**ADDENDUM NO. 1
NEW ELEVATOR
AT MURPHY ELEMENTARY SCHOOL
ROUND LAKE SCHOOL DISTRICT NO. 116
PROJECT NO. 23170**

Board of Education
Round Lake School District 116
884 West Nippersink Road
Round Lake, Illinois 60073

2 PARTIAL FIRST FLOOR ELECTRICAL DEMOLITION PLAN
1/4" = 1'-0"

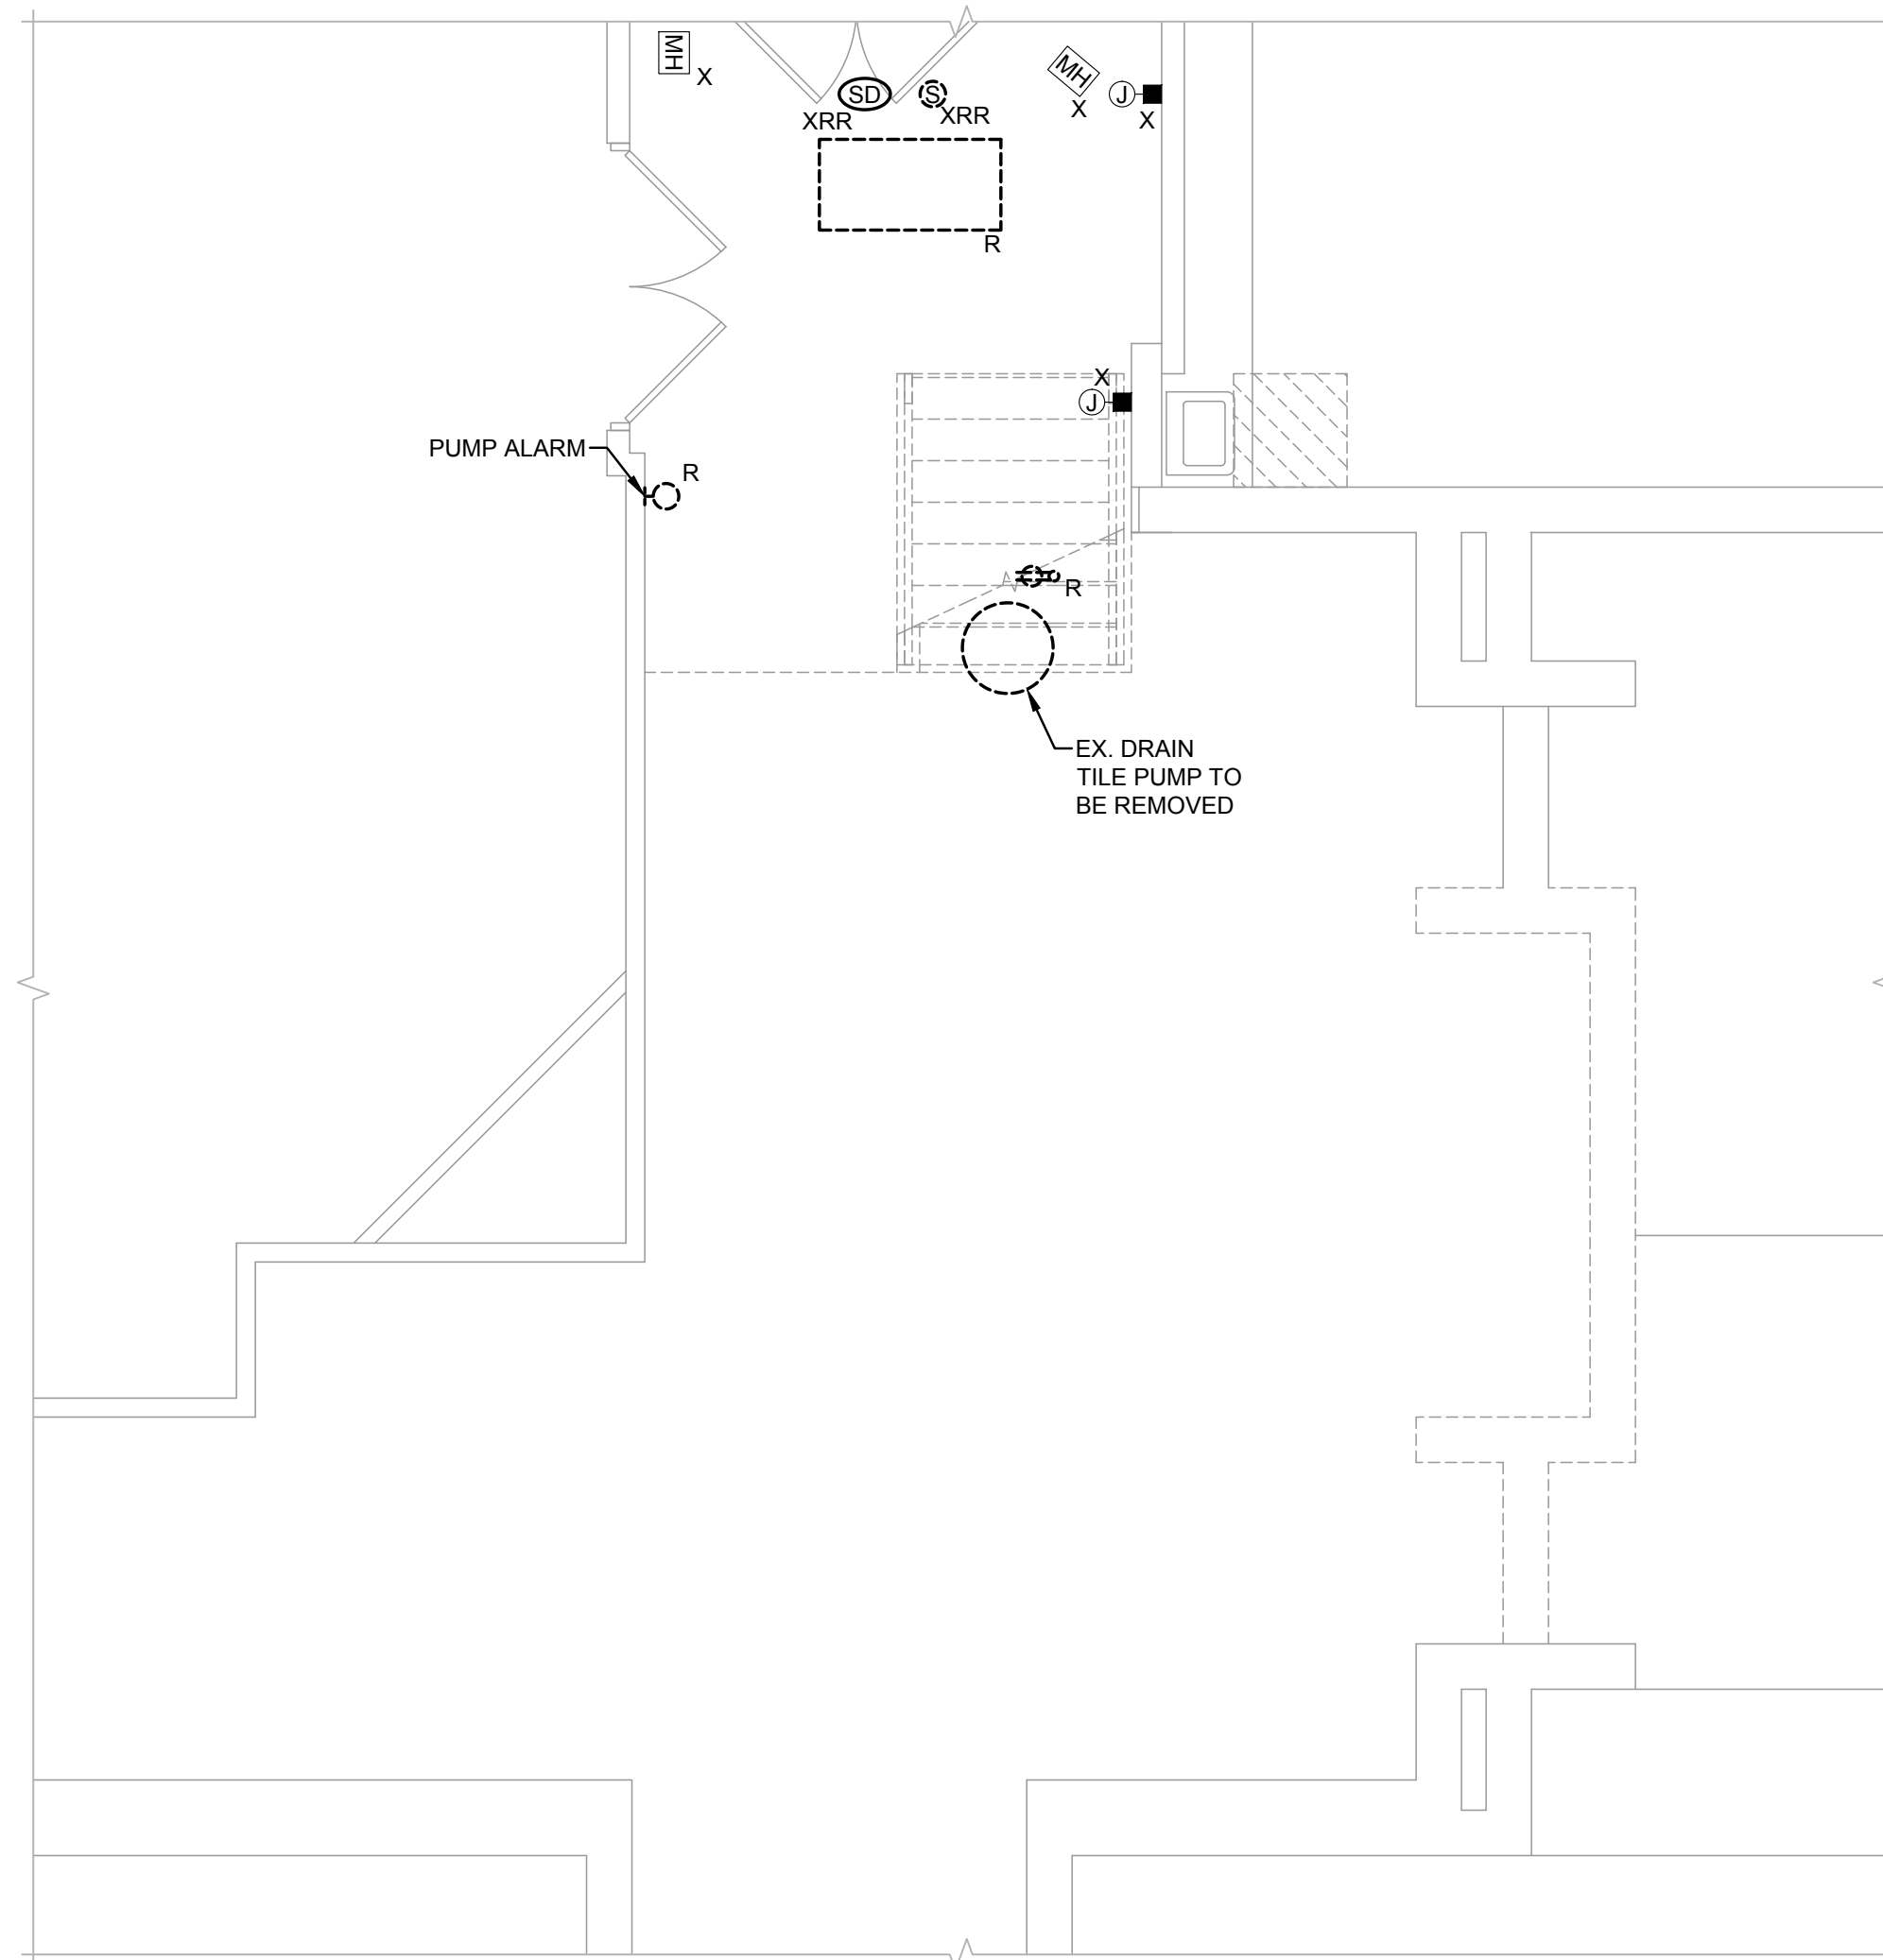
ITEM NO. 9: PROJECT DRAWINGS, E0.1, PARTIAL ELECTRICAL DEMOLITION PLANS

1. Refer to attached drawing E0.1 and refer to highlighted items for updates.

E1.1

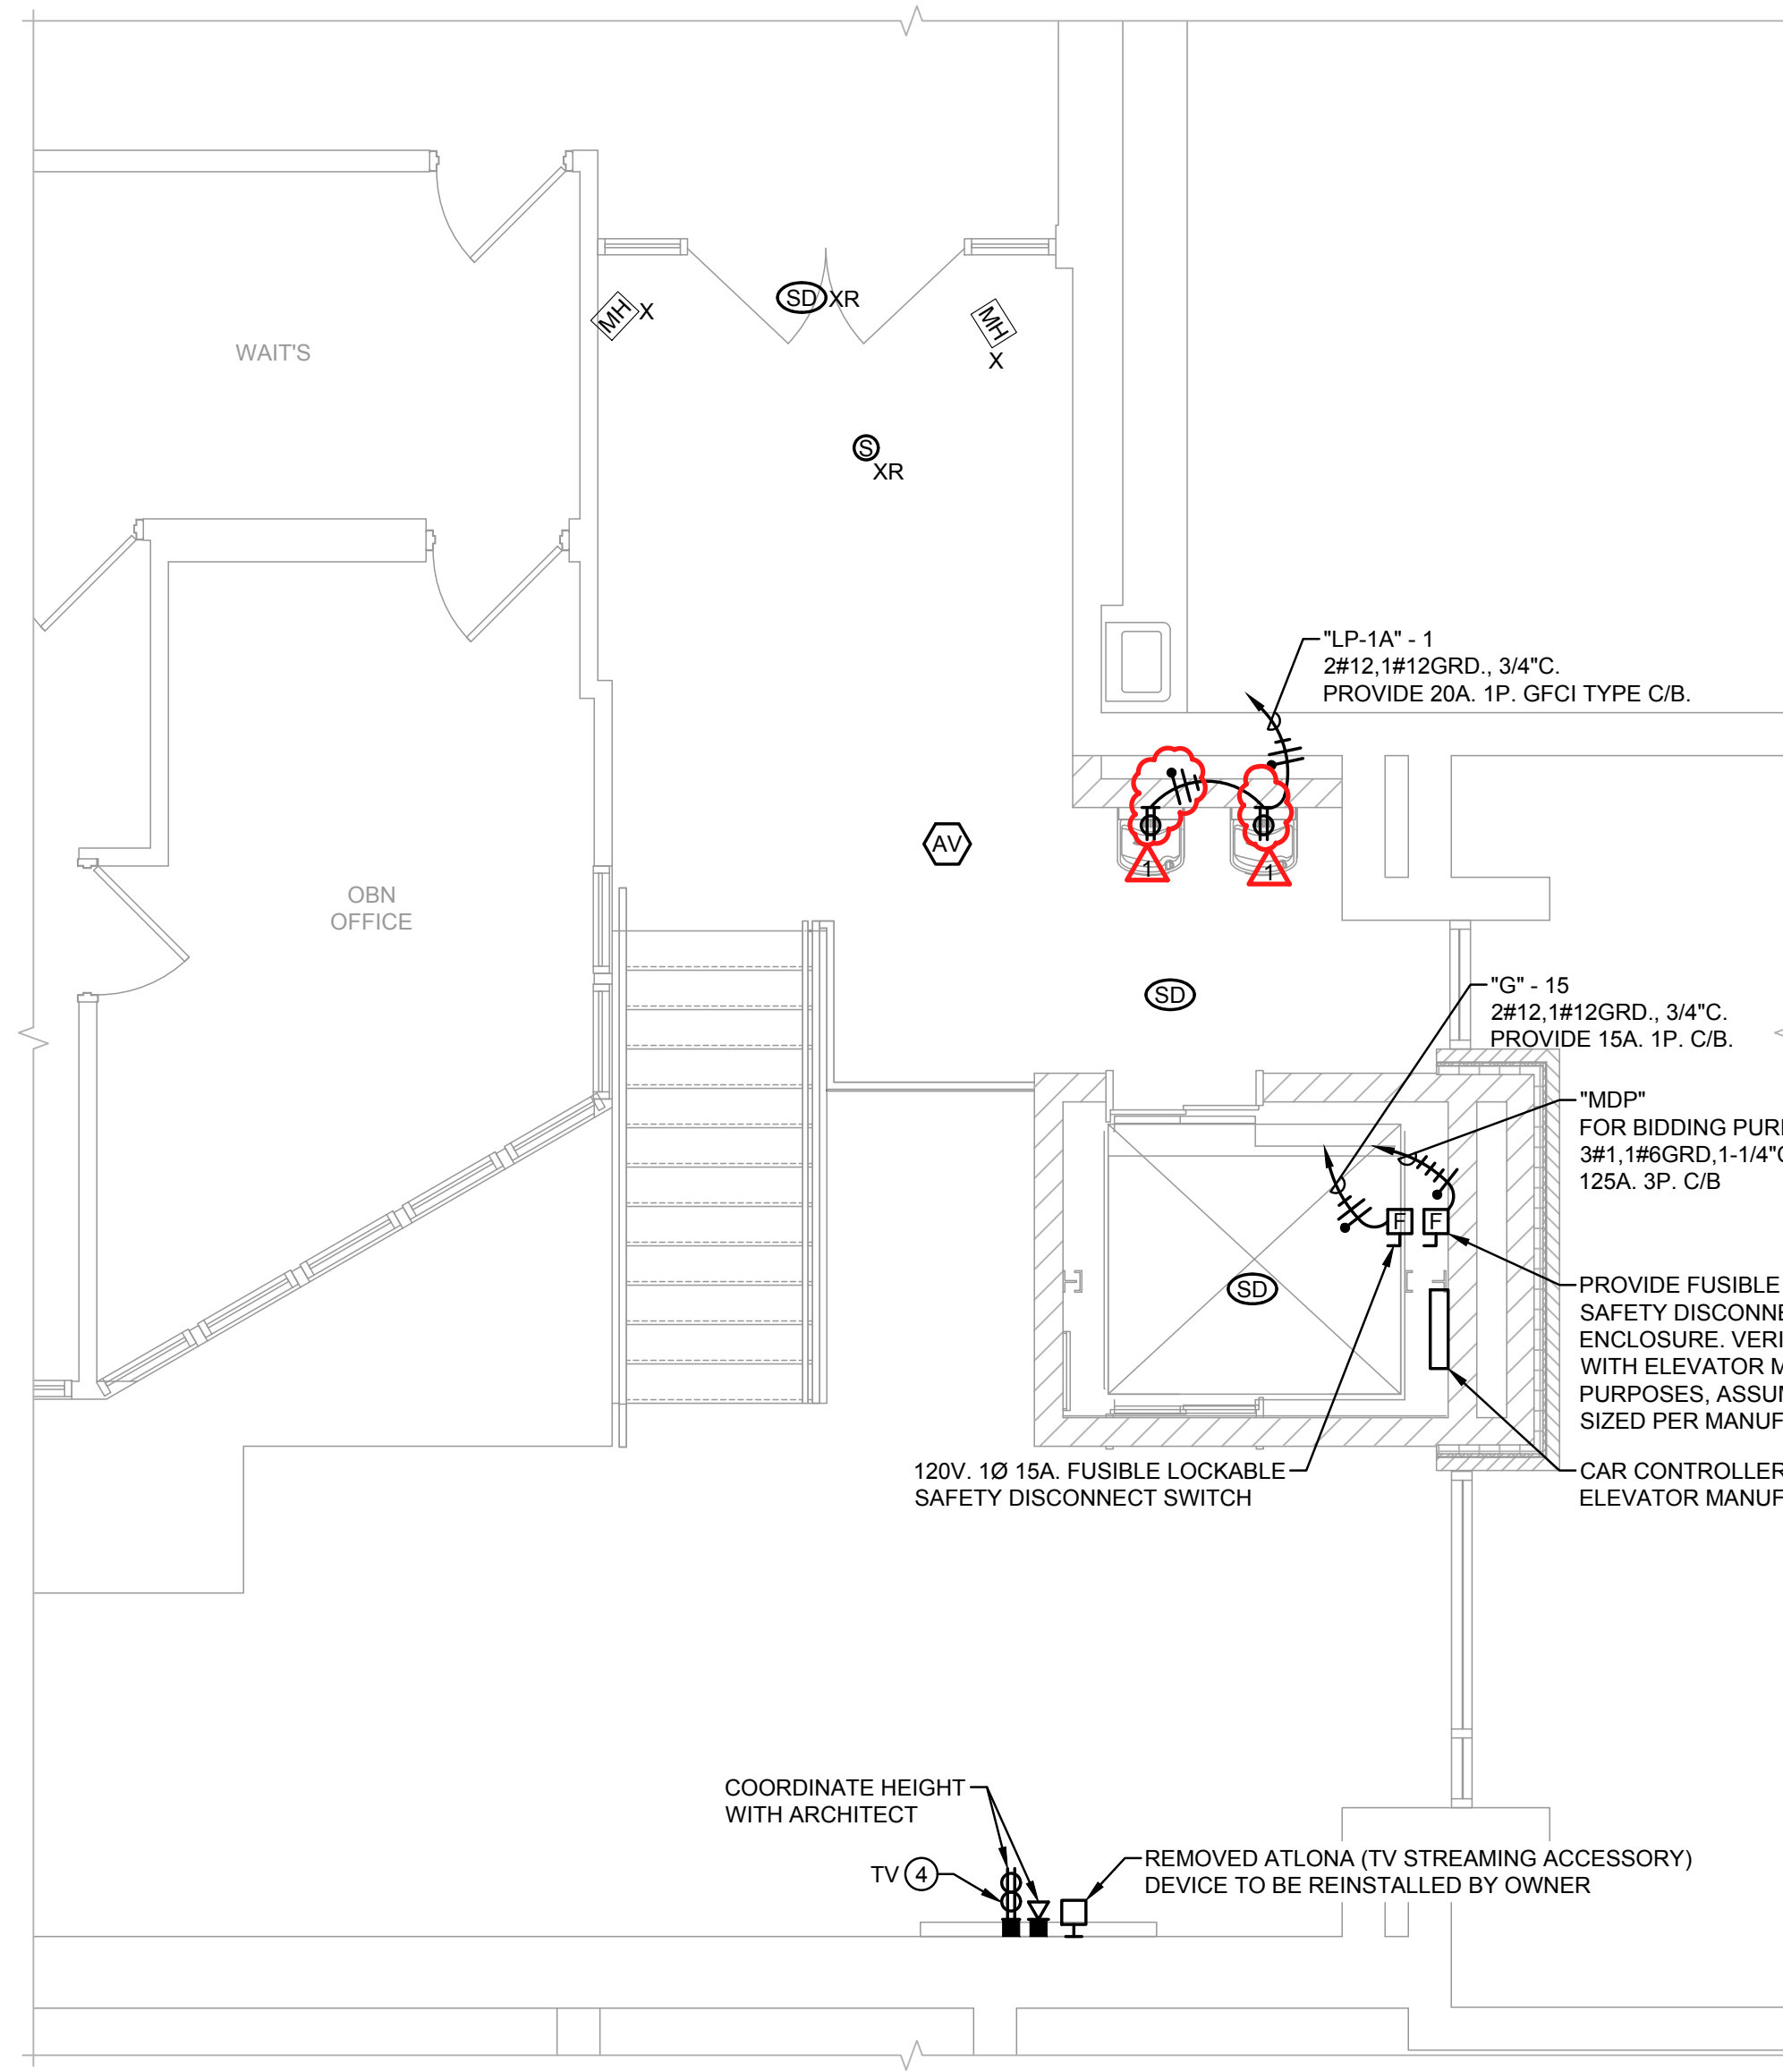
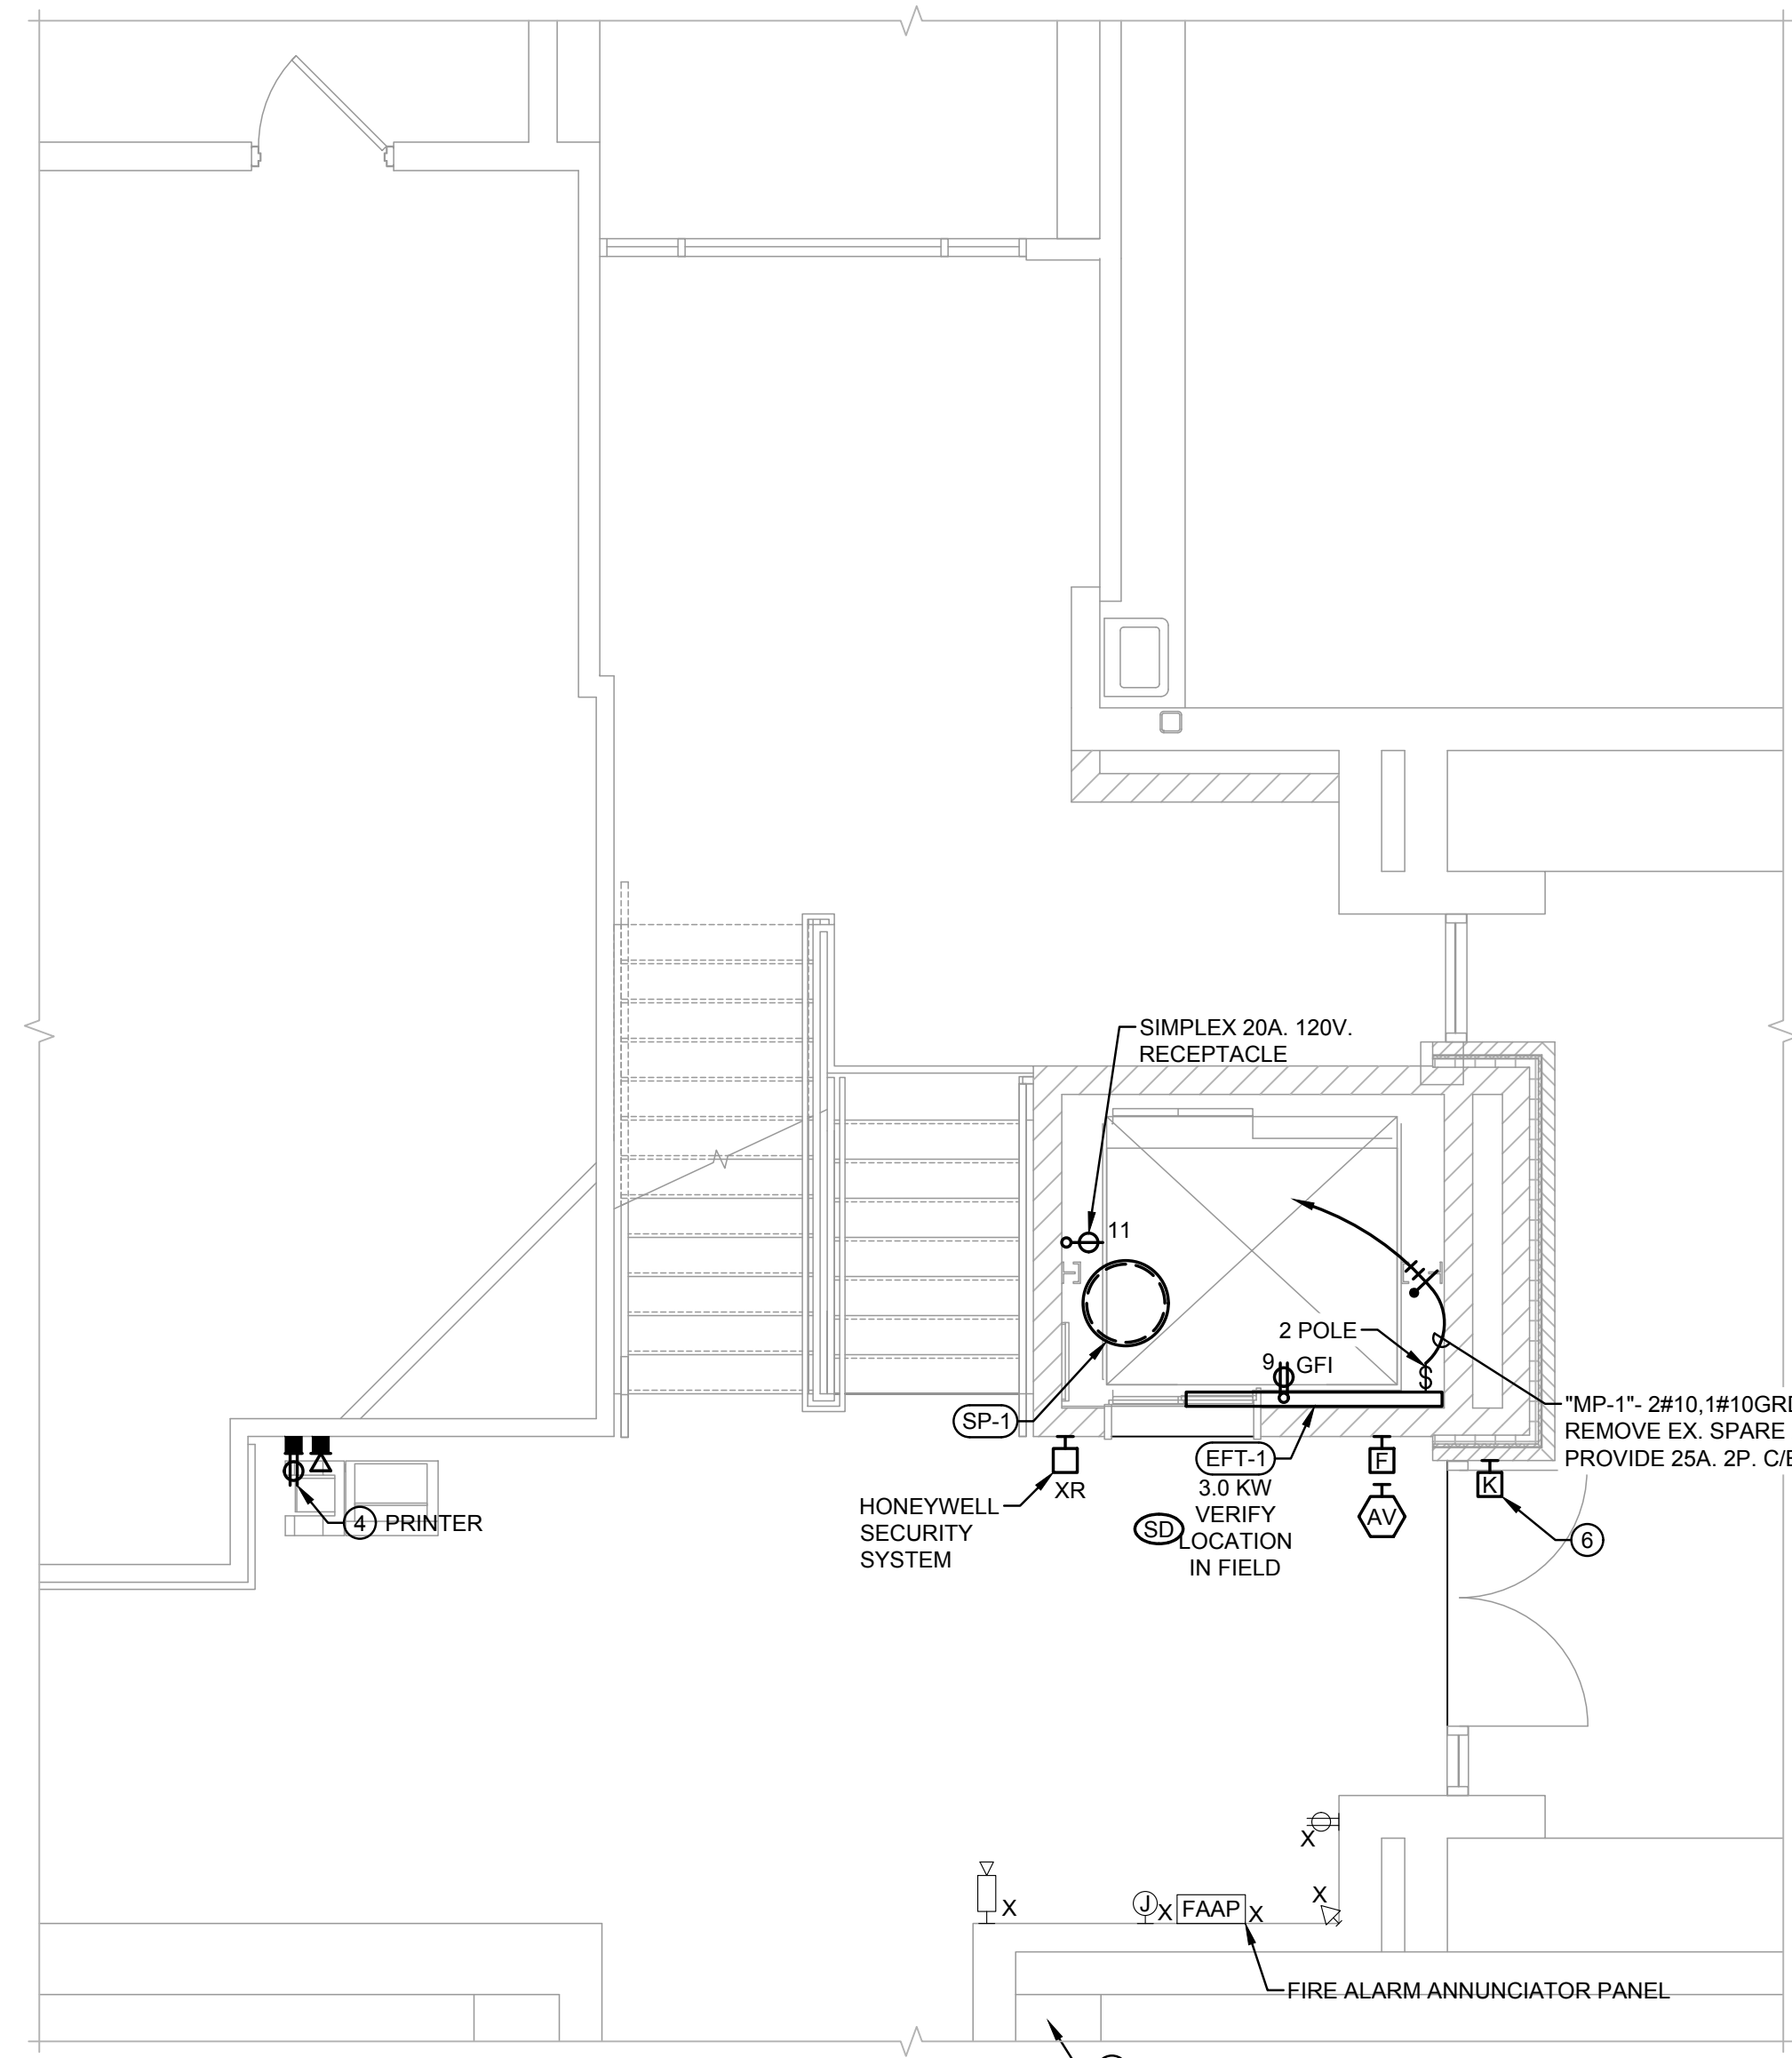
ITEM NO. 10: PROJECT DRAWINGS, E1.1, PARTIAL ELECTRICAL PLANS

1. Refer to attached drawing E1.1 and refer to highlighted items for updates.
